Bid Addendum 05

Project: Maritime Museum Education Center,
Beaufort, NC – Construction Phase Services

Date: August 2, 2024

SCO#: 24-27956-01A

TYPICAL GRASSPAVE2 DETAIL

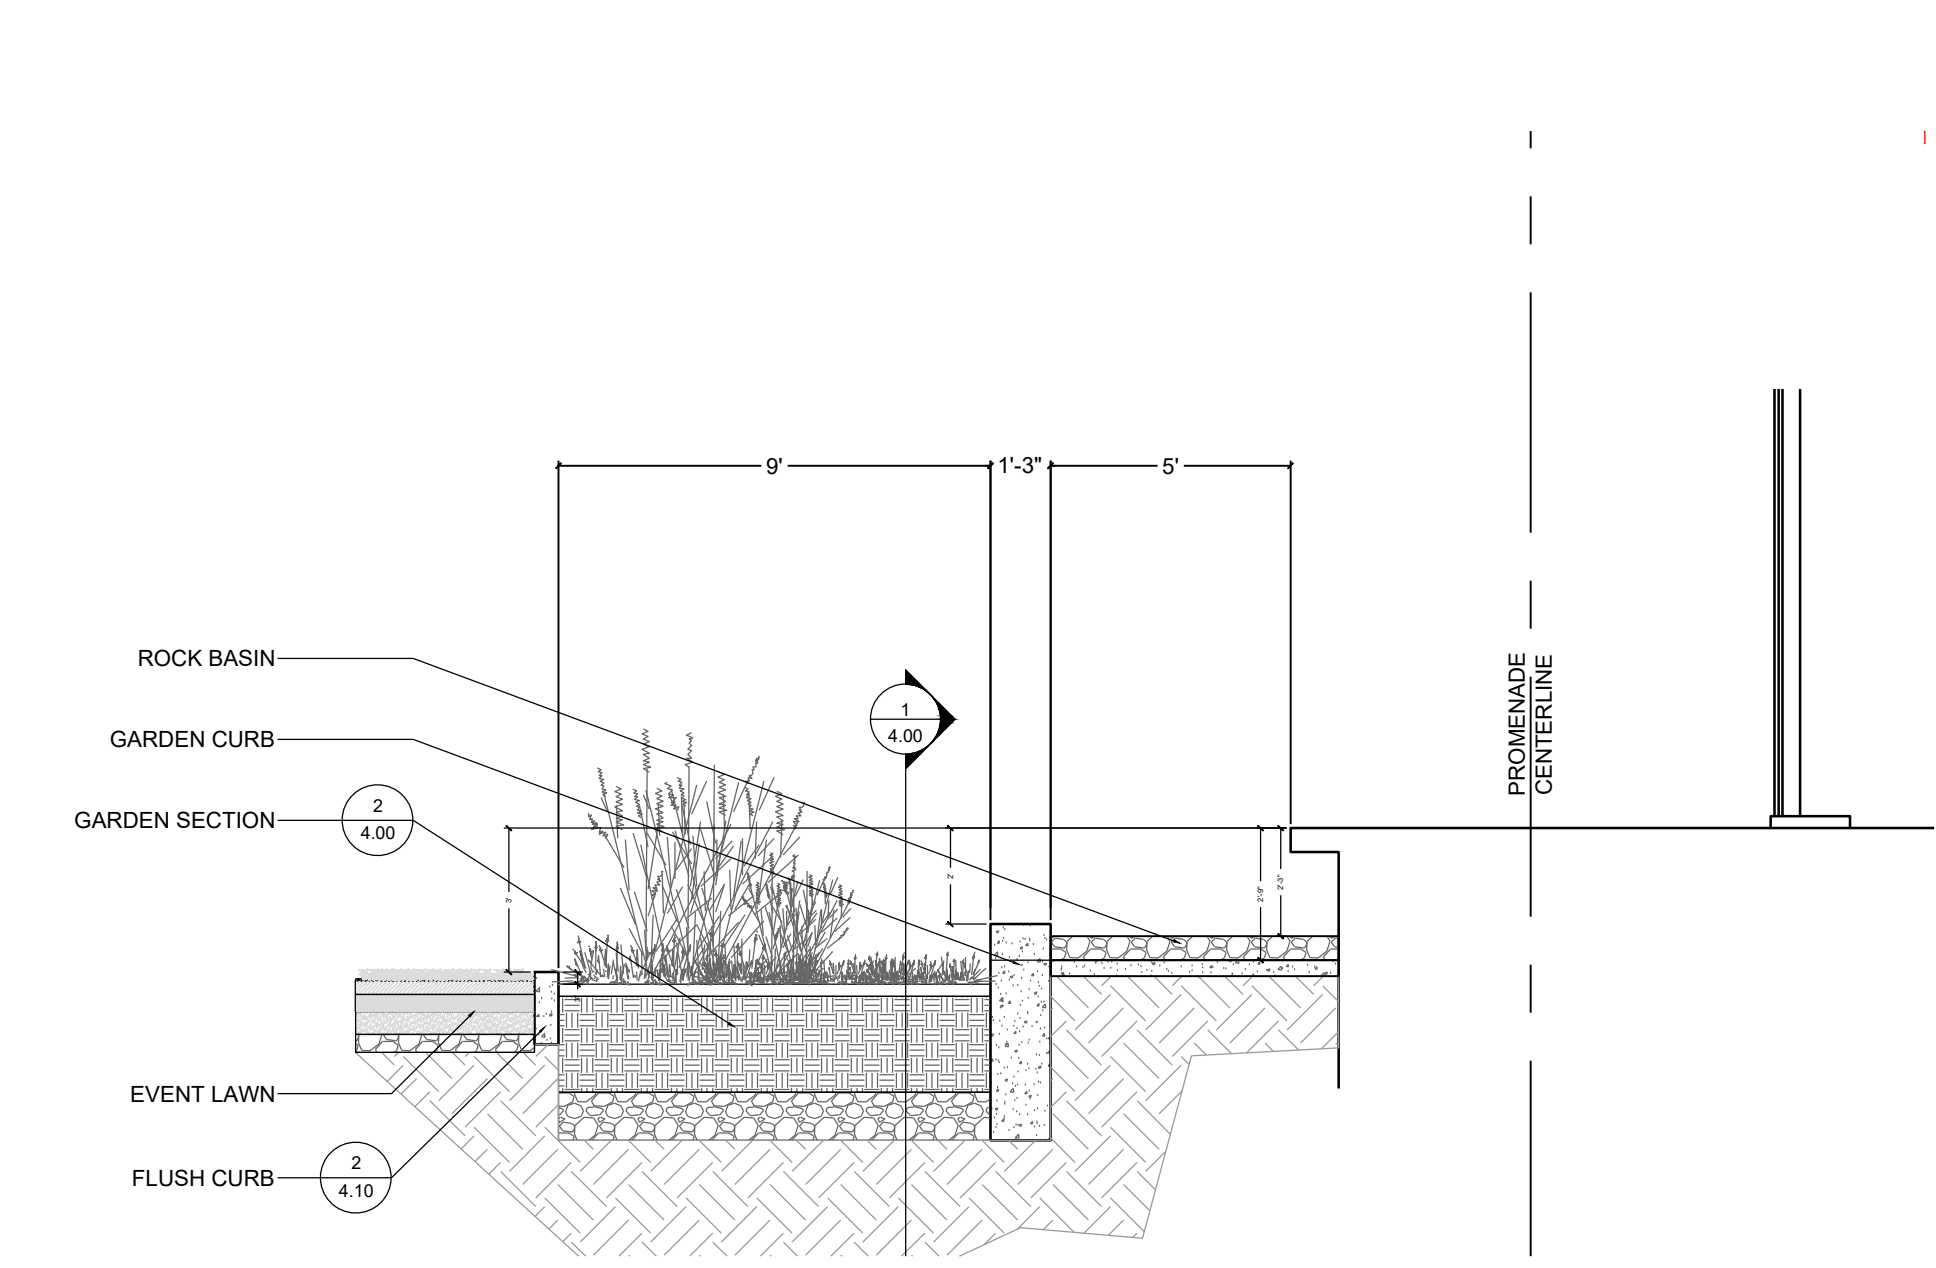
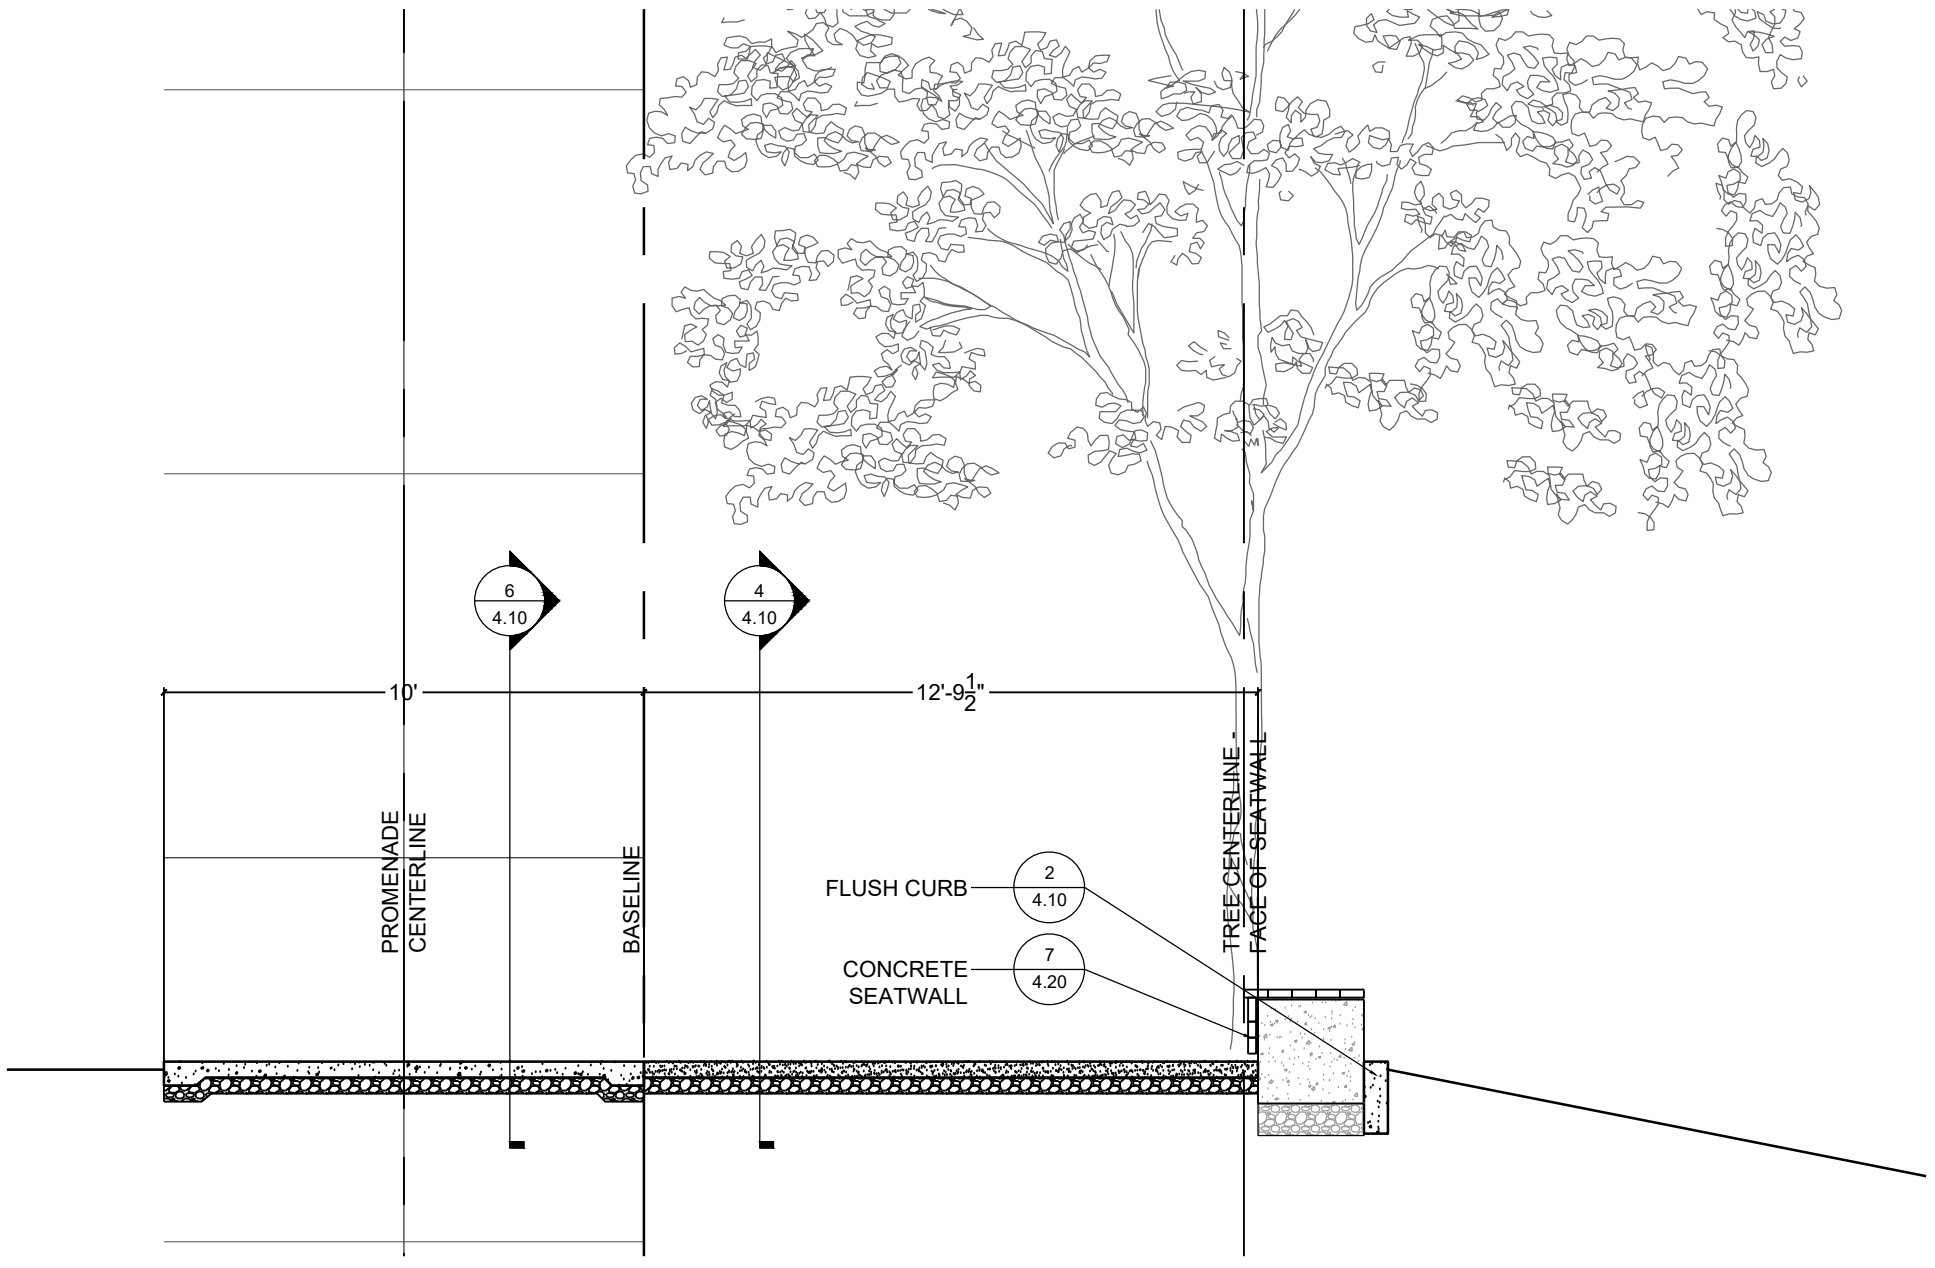
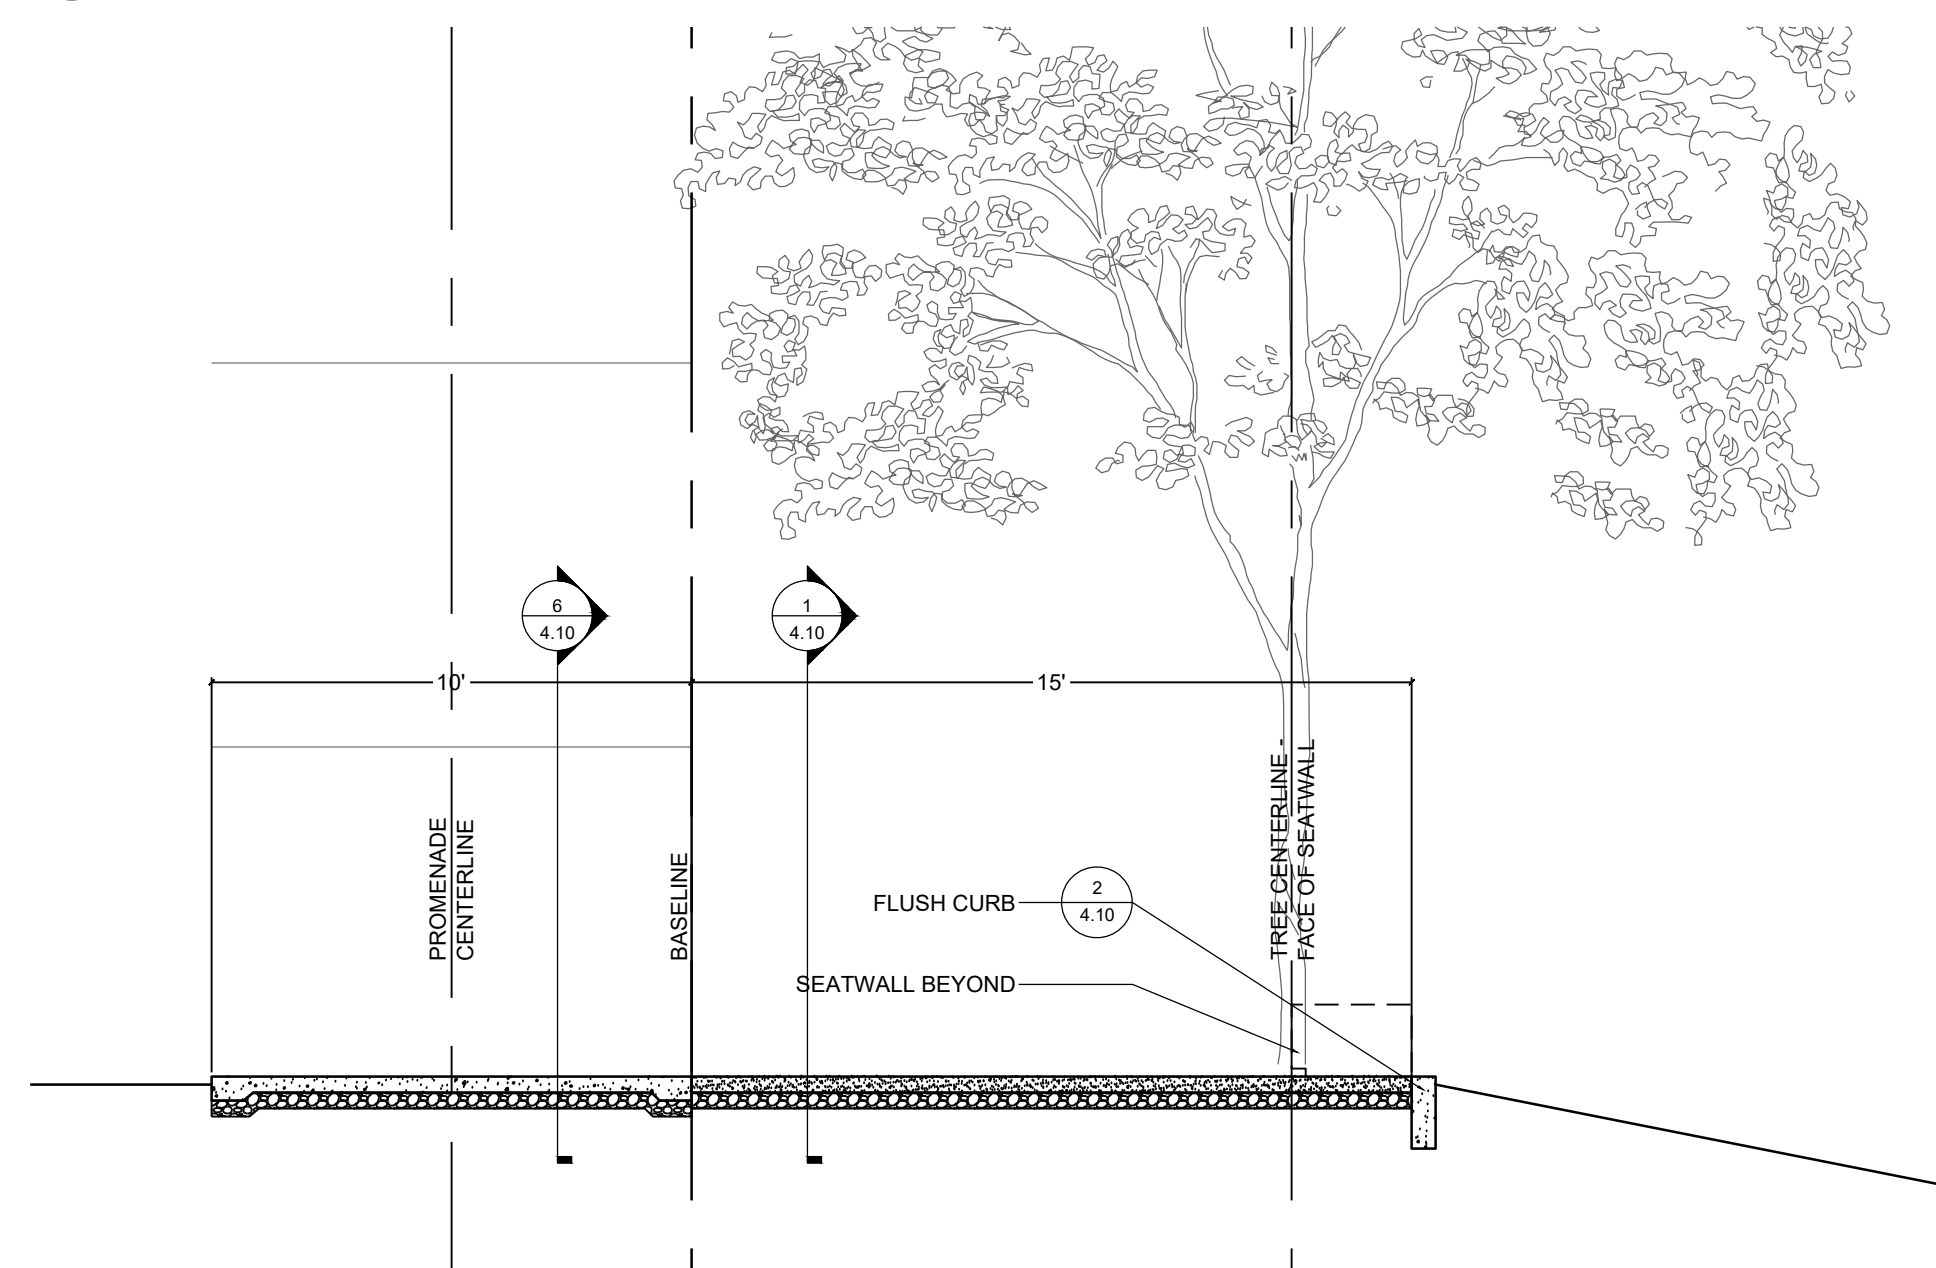
16. Sheet L4.00:
 - a. Detail 8 Grasspave2 Details has been added.
17. Sheet L4.00:
 - a. Detail 8 Grasspave2 Details has been added.
18. Sheet AE302
 - a. Sound Absorbing Wall callout has been added.

6. **QUESTION:** Please provide a cross-section for Grasspave (identified as P7 within Landscape drawings).
 - a. **RESPONSE:** Refer to attached sheet L4.00. Detail 8 Grasspave2 Detail has been added.
